Petition No. 1222  
Interrogatories  
Set One  
April 14, 2016

Windham Solar LLC (WS) Responses April 28, 2016

**FISK ROAD SOLAR**  
 390 HARTFORD TURNPIKE  
 HAMPTON, CT 06247  
 WINDHAM COUNTY

**OVERALL SITE PLAN**

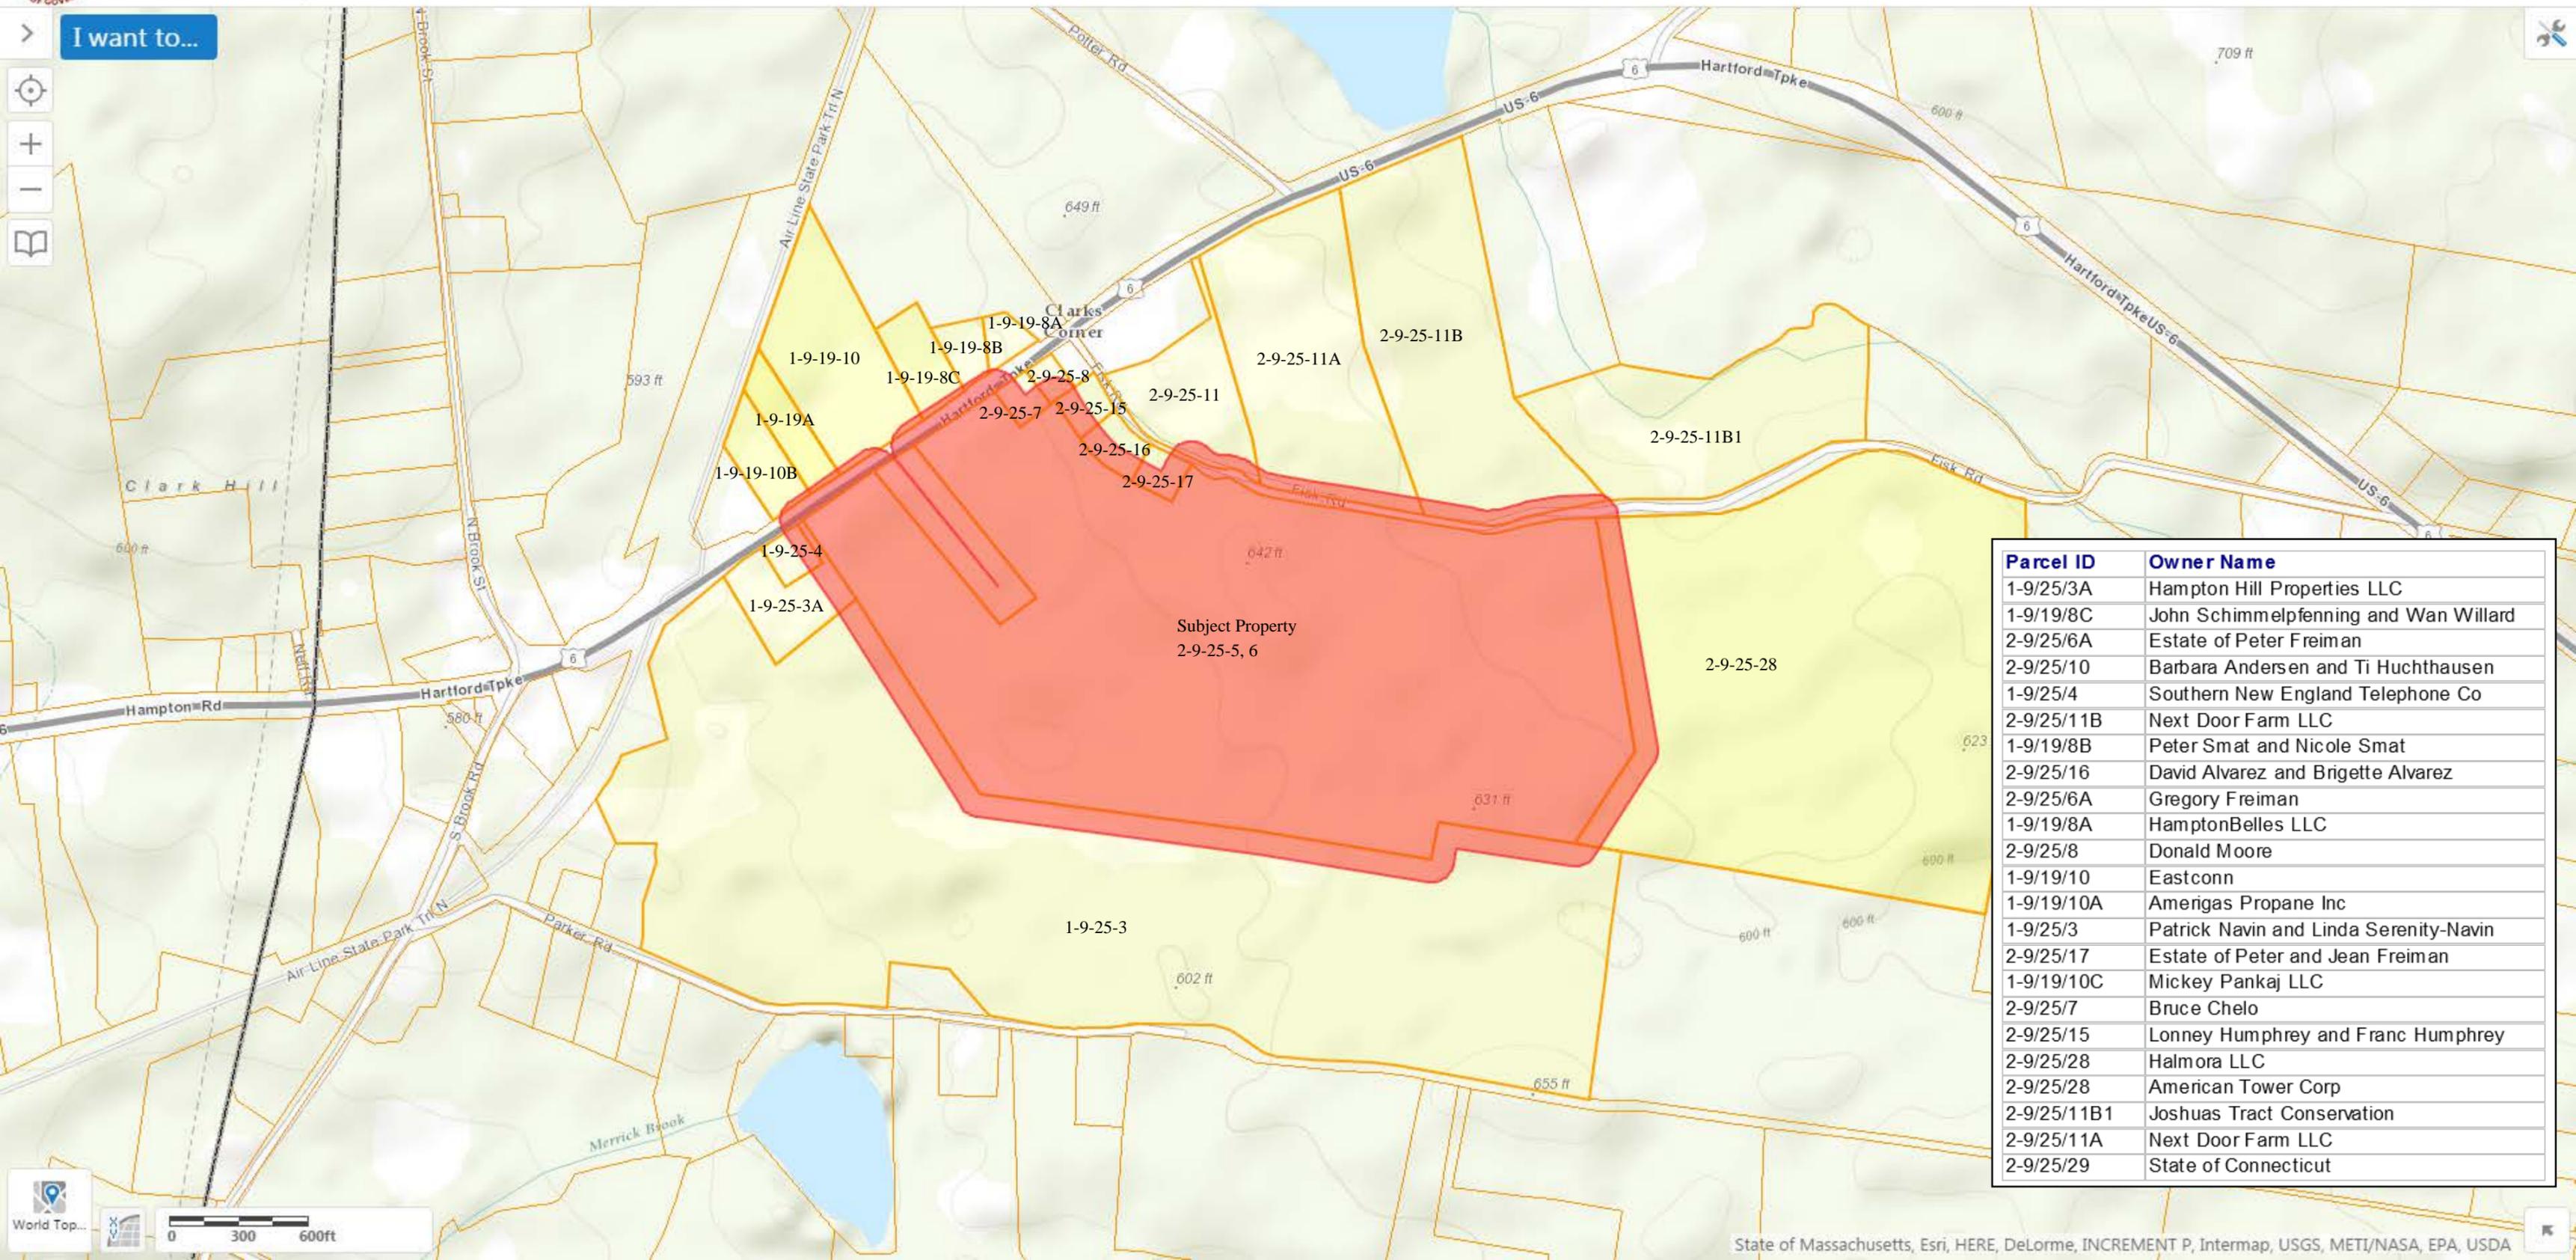
40. Explain in text the reasons for the changes to the site plan such as municipal comments and resident concerns and/or any environmental issues at the site.

Improvements to Fisk road will be necessary, the project is getting a much more detailed survey of the roadway area to produce a realistic design for a revised final access roadway alignment. Any widening of the roadway will be to the south, ensuring that the abutter to the norths land is not encroached upon.

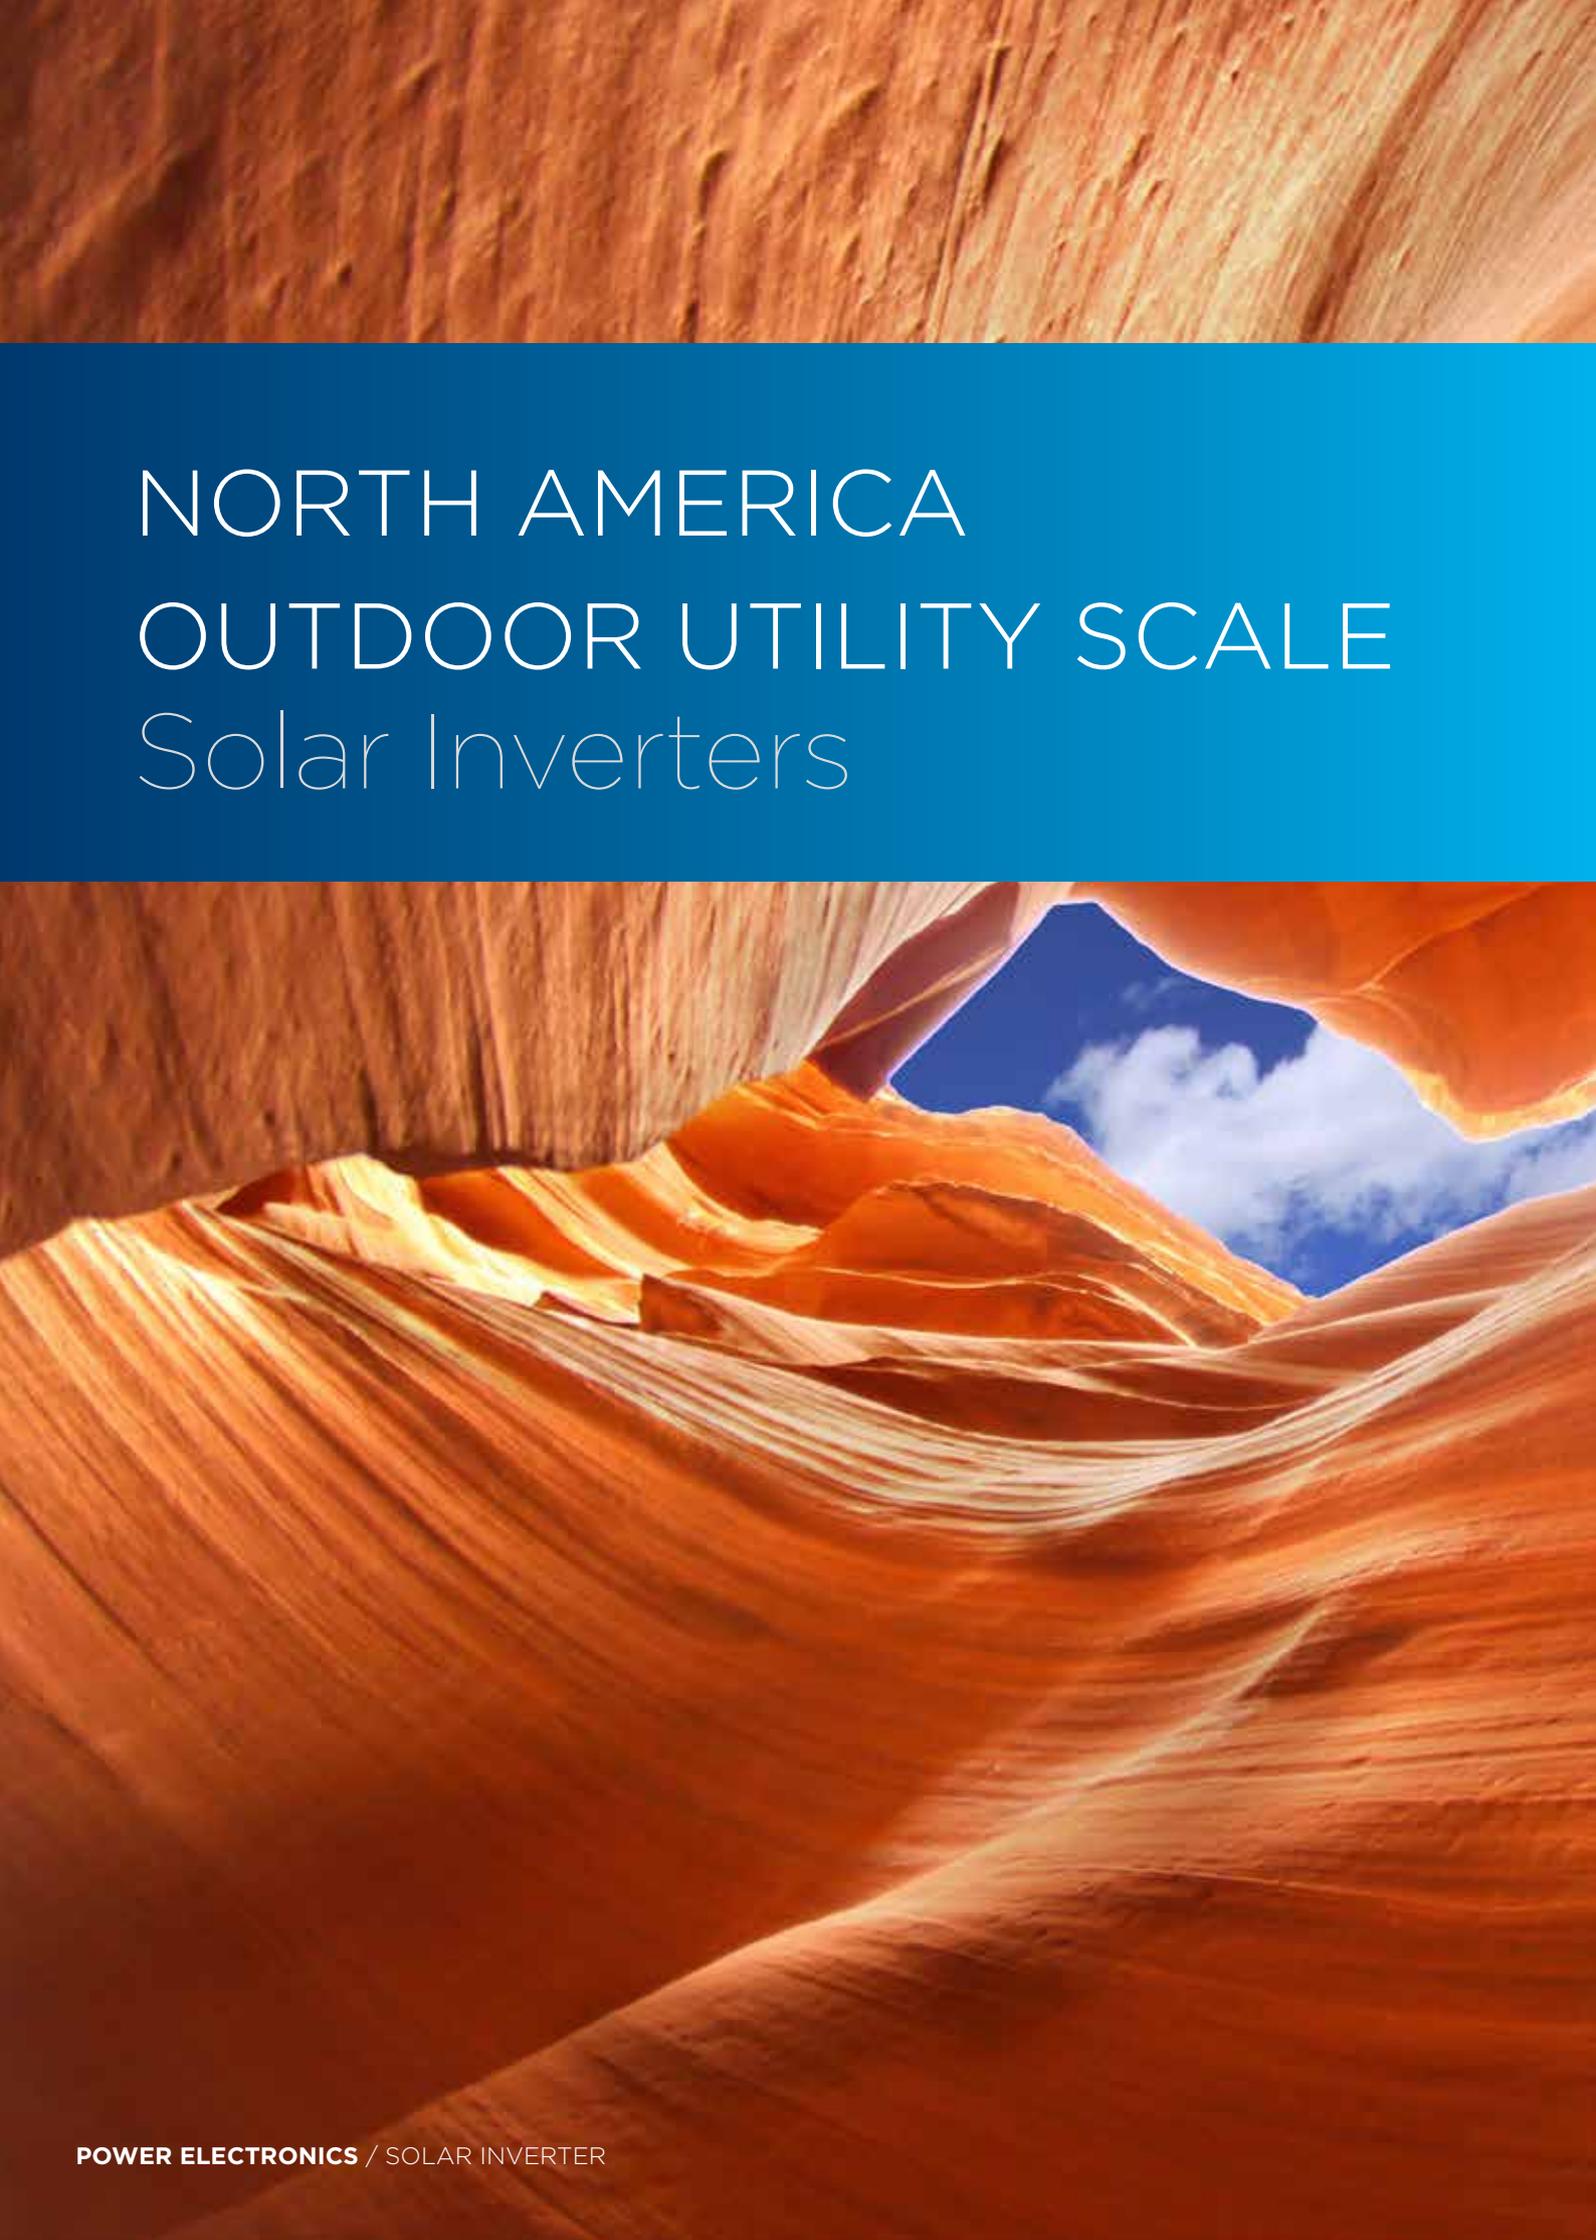
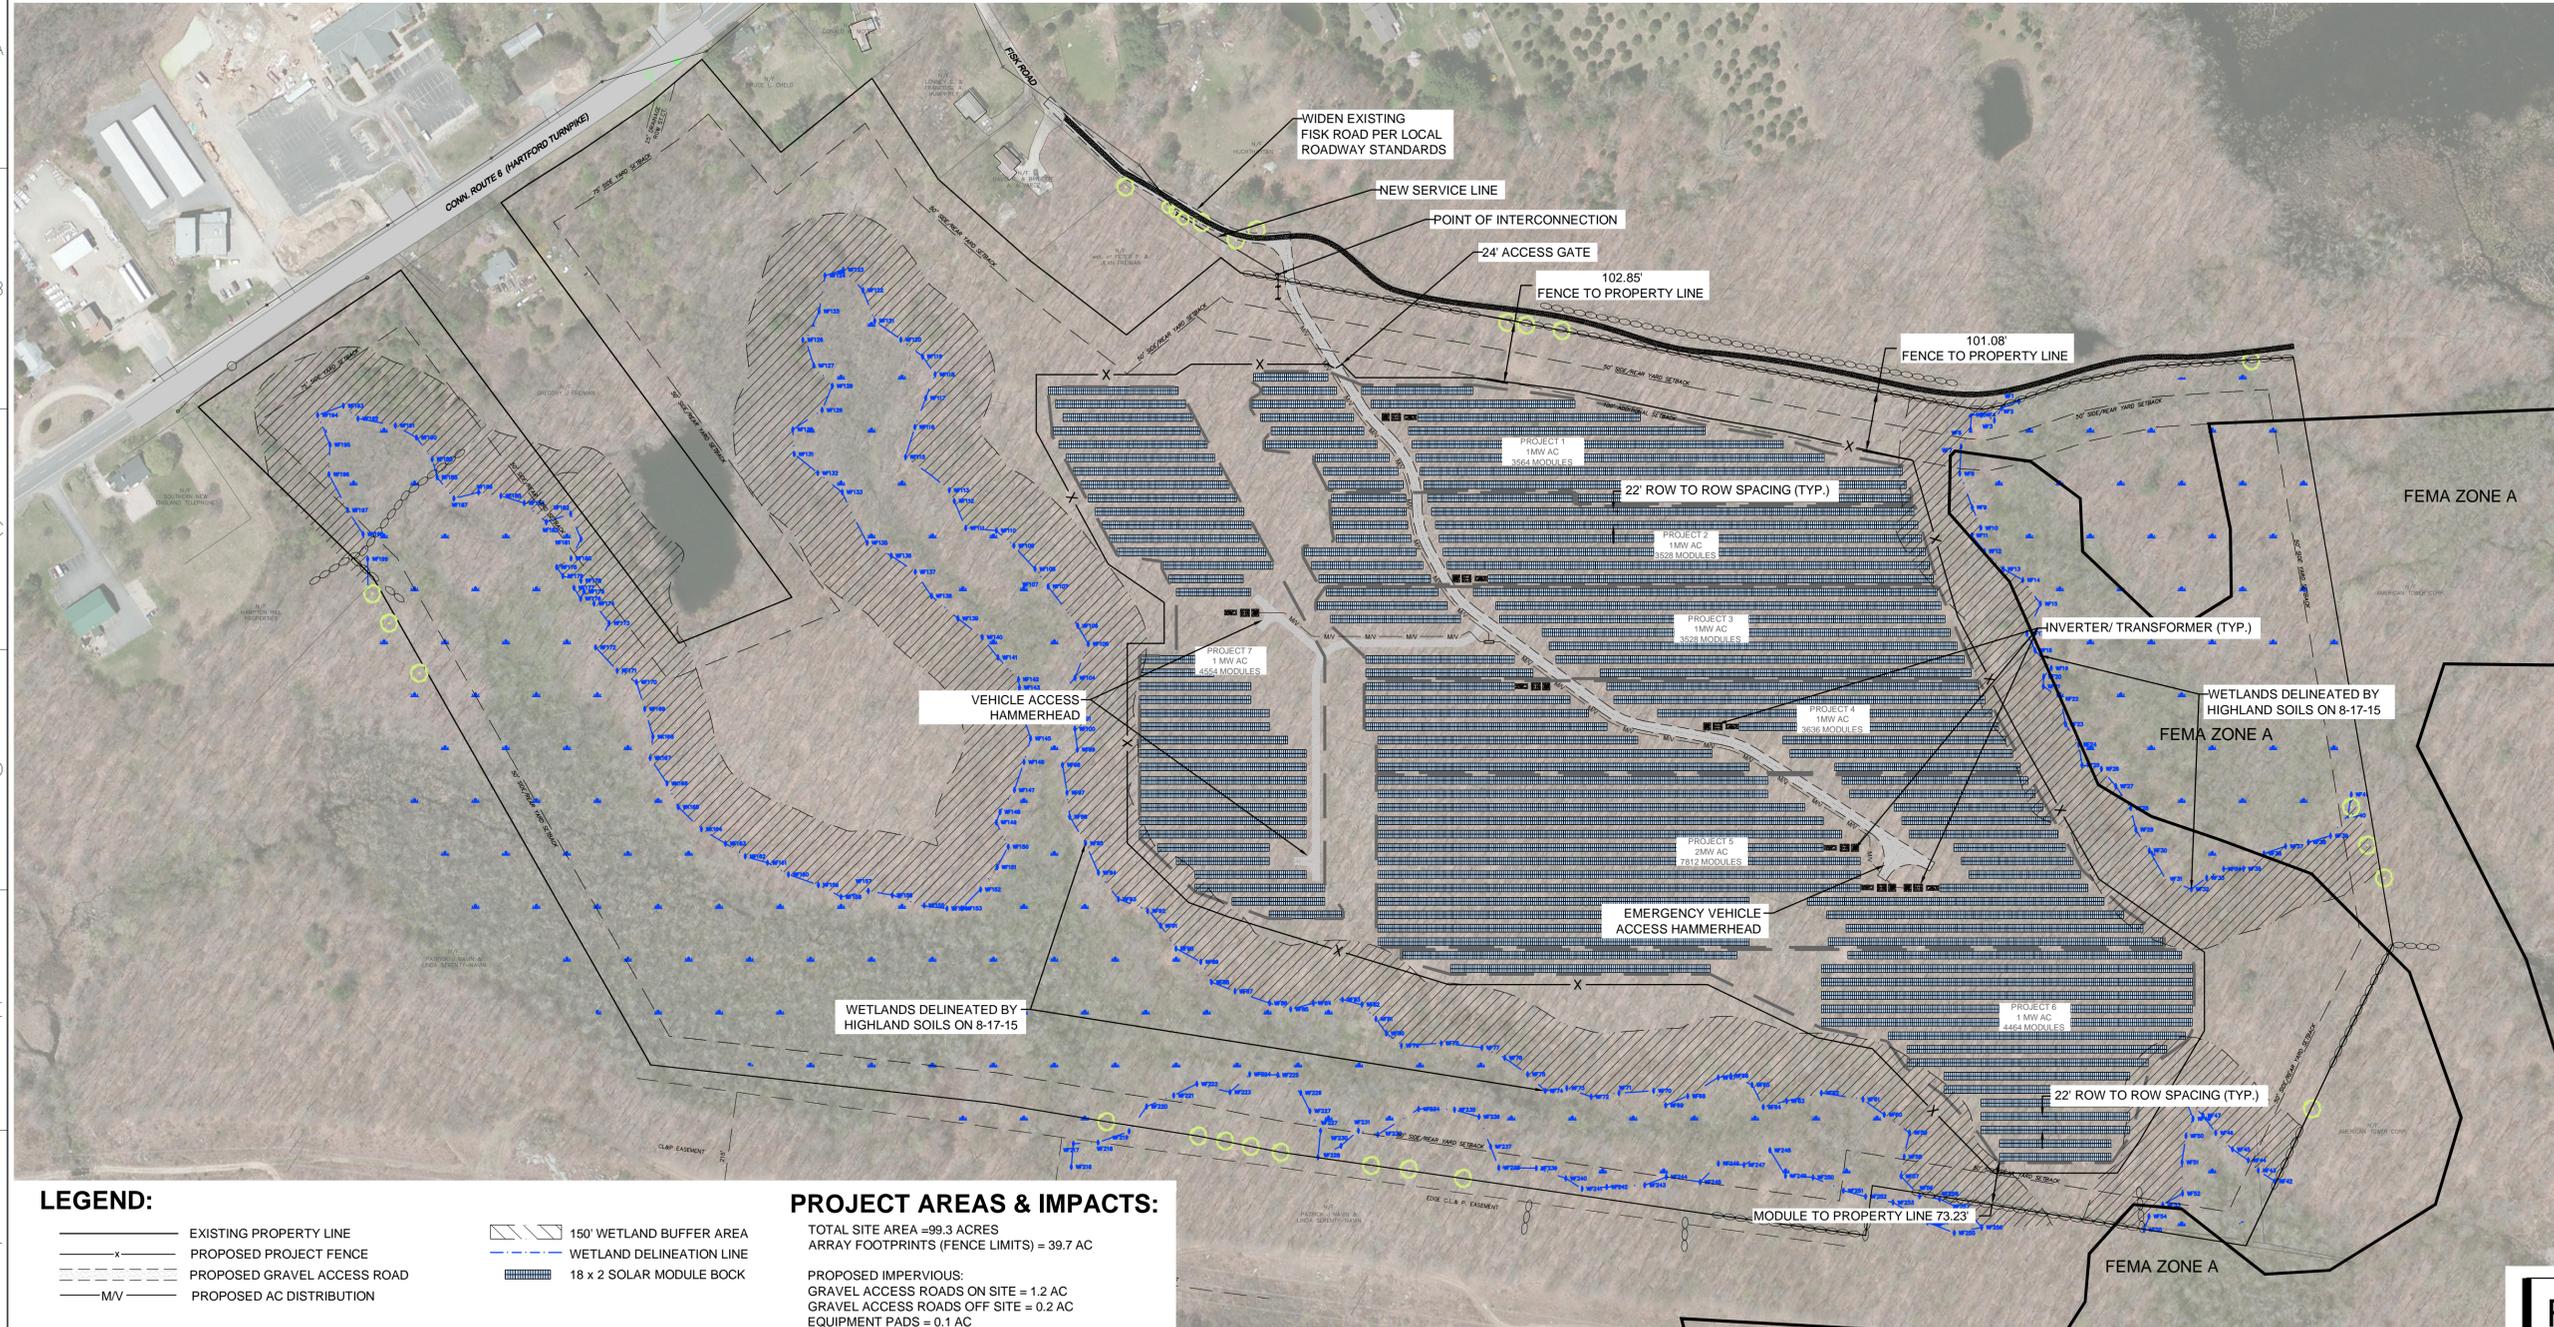
4. Indicate which solar arrays on the Overall Site Plan (Sheet 4 of 17) are the 2.0 MW arrays and which arrays are the 1.0 MW arrays.

5. Page five of the Petition indicates that, "Each 2.0 MW Facility will consist of approximately 6,790 solar modules and the 1.0 MW Facilities will consist of approximately 3,395 solar modules (based on a module rating of 345 watts)." Thus, would the total number of solar modules be equal to 33,950?

39. Please provide the most up to date Overall Site Plan Drawing (Sheet 4 of 17) taking into account any revisions that have been made to the number and locations of solar panels proposed, megawatts proposed, access proposed, etc.

The site plan has been revised per the site visit on April 21<sup>st</sup>, 2016 and boundaries have been added to the overall site plan, illustrating each array area. – Exhibit B

Boundaries have been added to the overall site plan illustrating each array area and total module counts. The total modules on the site plan is currently 31,086 – Exhibit B

A revised site plan is attached – Exhibit B

The Facility has been pushed an additional 50' south from the property line abutting Fisk Road, for additional screening from residences to the north.
